## **Proposal for amendments to Regulation N°107 (M<sub>2</sub> and M<sub>3</sub> vehicles)**

The present document is tabled by the GRSG informal group on Service Doors, Windows and Emergency Exits (SDWEE) as an intermediate proposal for amendments to the Regulation N°107. Amendments to the current text of the Regulation are indicated in bold and strike-through characters.

Figure 26

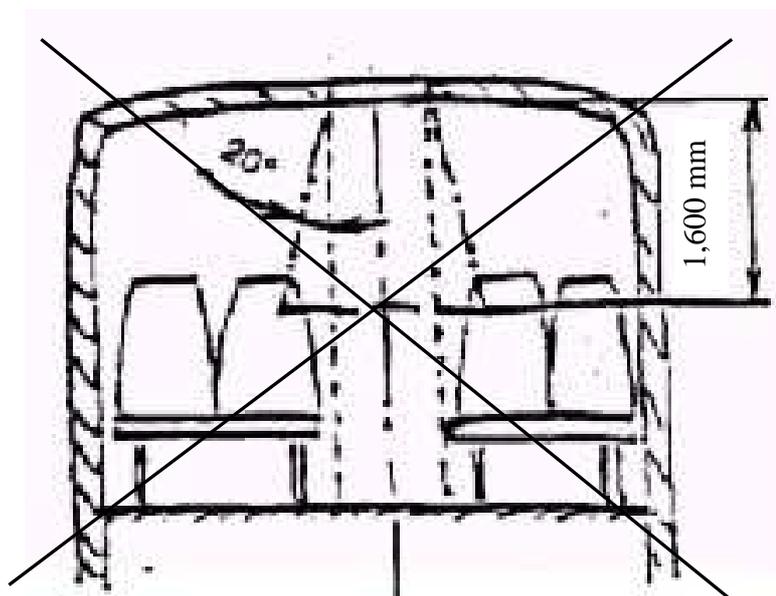
*Annex 4, figure 26, amend to read:*

Reserved

Reports on bus accidents have shown that the emergency hatches in the roof are only used when the bus or coach has tilted. While the bus or coach is in the driving position the emergency hatches are not used by the passengers in the case of emergency.

Therefore it seems justifiable that no exit support is required.

The figure N°26 to which these paragraphs refer should be deleted as well.

*Delete paragraphs 7.7.4.1.1. and 7.7.4.1.2.*
